SERVICE BULLETIN

Dometic GmbH, In der Steinwiese 16, D-57074 Siegen

RM/S 8500/01/05/50/51/55, RMD/T 8501/8505/8551/8555

Change position of door locking device

pic 1

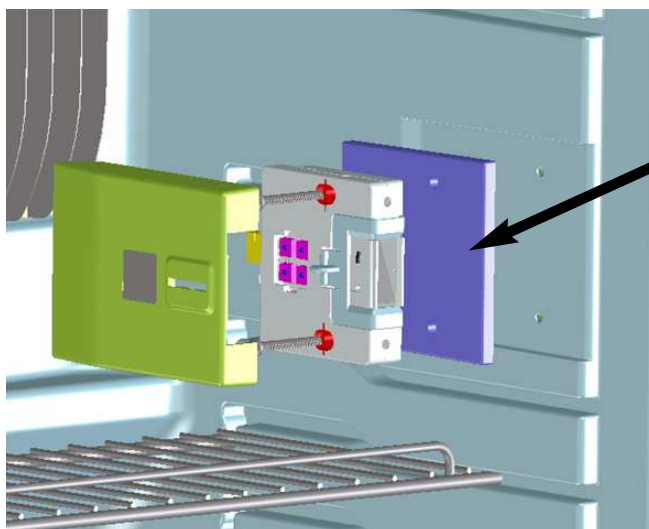
In above mentioned fridges the position of the latch has changed (pic. 1+2).
If the door of one of these models will be exchanged, a space plate (spare part number 295 1973-20/1) has to be installed under the door lock (pic. 3).

Activation rod of the door locking device get stuck

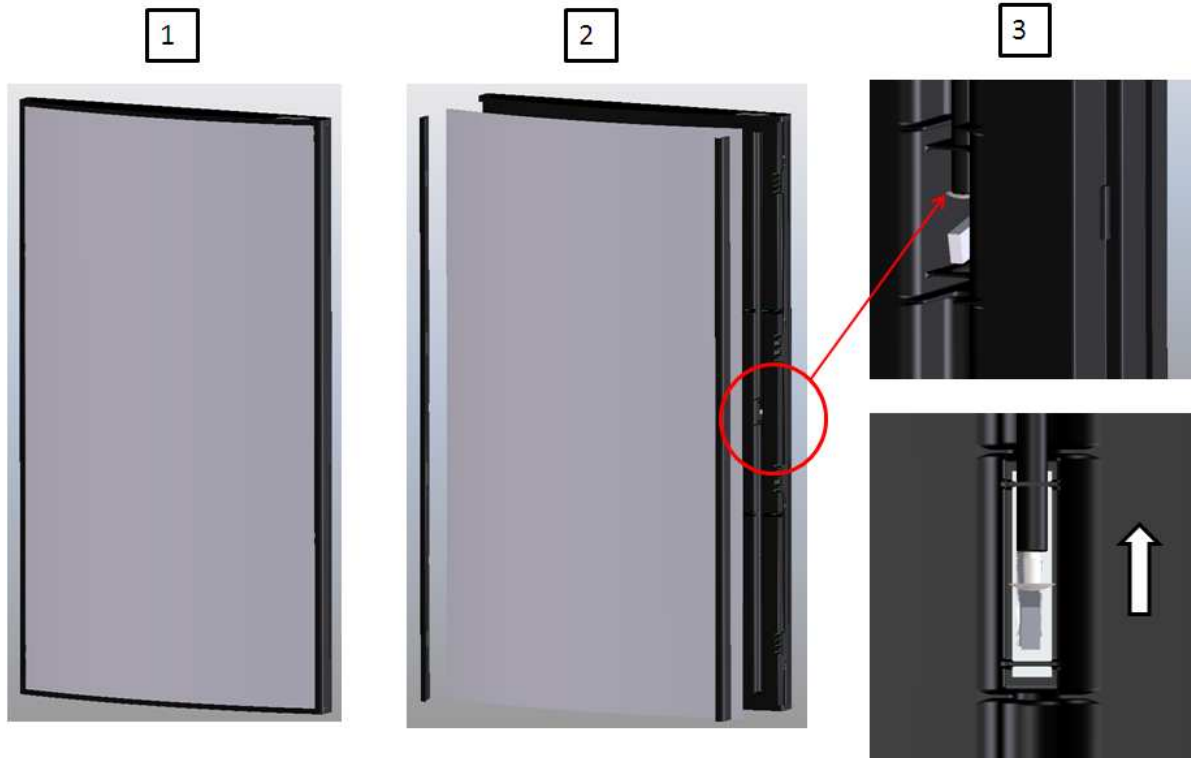
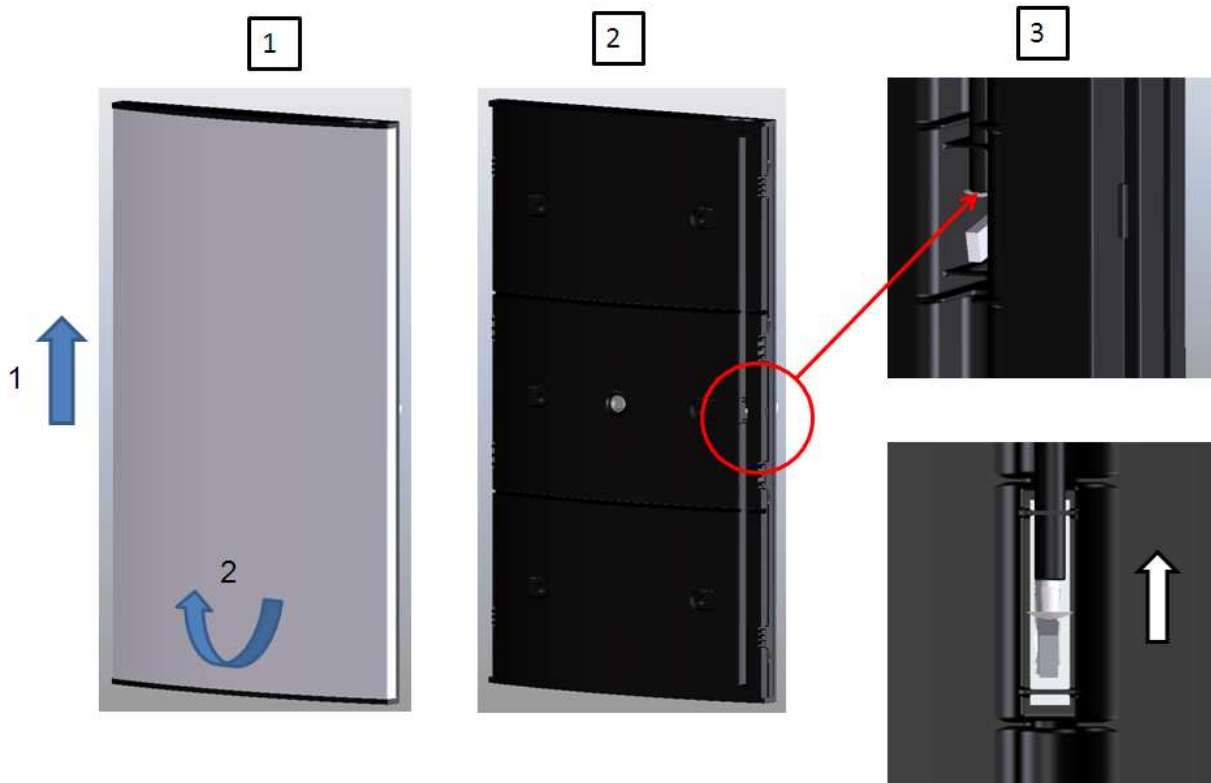
In above mentioned fridges the activation rod can get stuck. In this case, please install the expanding rivet (spare part number 292 3142-06/7 (1 piece) or 241 2559-17/7 (5 pieces)).

Insulation strip for door locking device in freezer compartment

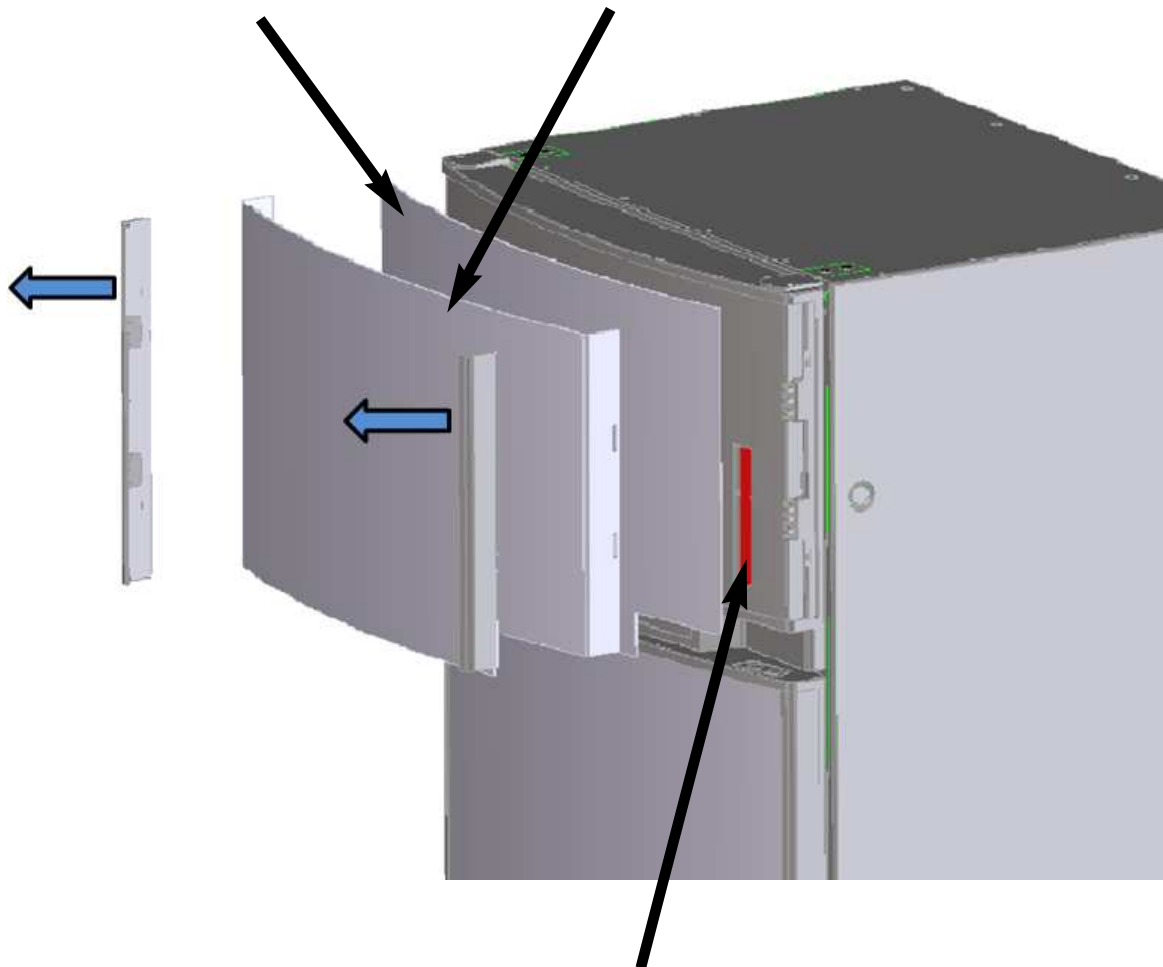
In above mentioned fridges condensed water can arise on the decoration panel and the door locking device can be frozen. In this case please install insulation strip (spare part number 293 5688-21/4).

Take off the cover strips and push the decoration plate up and take it away.

Push the decoration plate to the left side and take it away.

Insulation strip 293 5688-21/4
